A Public Participation Process (PPP) for the EMPr and Layout Plan finalisation process for the Establishment of a Wind Energy Facility situated on the Eastern Plateau (South), near De Aar, in the Northern Cape Province (also referred to as the De Aar 2 South WEF), has been undertaken to provide registered Interested and Affected Parties (I&APs) and relevant State Departments and Organs of State with an opportunity to comment on the draft Amended EMPr and proposed Final Site Layout Plan, in furtherance of compliance with Conditions 13, 14, 15, and 16 of the Environmental Authorisation (EA)¹ (DFFE Reference No. 12/12/20/2463/1/MP1).

Table 1: Comments and Response Report (CRR)

Figure 4: The proposed turbine exclusion zones Jackal Buzzar nests, boreholes, dams and escarpment edge, and turbines (white points) including those with ines to be curtailed (red points).

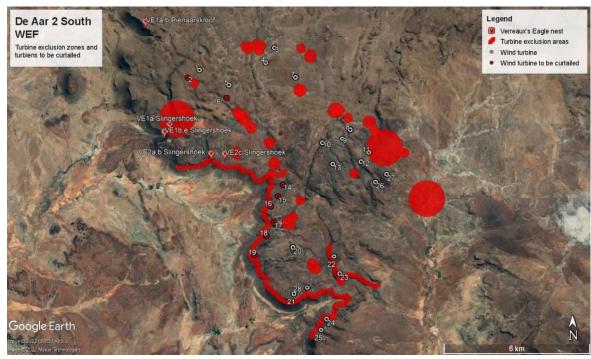
5a.3.  c. There is an inconsistency noted in figure 2: sensitivity map and figure 4: turbine exclusion zones included in the draft EMPr, whereby turbines 2, 11, 26 to 19 and 22 to 25 are located within or at the edge of the exclusion area. You are advised to	5a.3 The Applicant responded:  Upon close inspection, Turbines 11 and 25 were approximately 2 m into the exclusion zone, due to a mapping error. This has been corrected and turbines 11 and 25 are now outside of the "no-go" areas in the

No.	Date of comment, format of comment, name of organisation / I&AP	Comment	Response from EAP / Applicant / Specialist
		9a.5. Page 57, Figure 4: The proposed turbine exclusion zones Jackal Buzzard nests, boreholes, dams and escarpment edge, and turbines (white points) including those turbines to be curtailed (red points)"  SR commented "Please also indicate exclusion zones for VEagle."  (Refer to Appendix 1 of the CRR for the full context).	9a.5. The avifaunal specialists (Chris van Rooyen and Albert Froneman) responded:  A 1km all infrastructure exclusion zone must be implemented around all Verreaux's Eagle nests to prevent disturbance of the breeding pair(s) except for authorised linear infrastructure. If linear infrastructure is needed in these areas, then construction thereof must avoid the breeding season.  The EAP responded:  Figure 4 has been updated to include the Verreaux's Eagle nest exclusion zones for all infrastructure (except for authorised linear infrastructure).
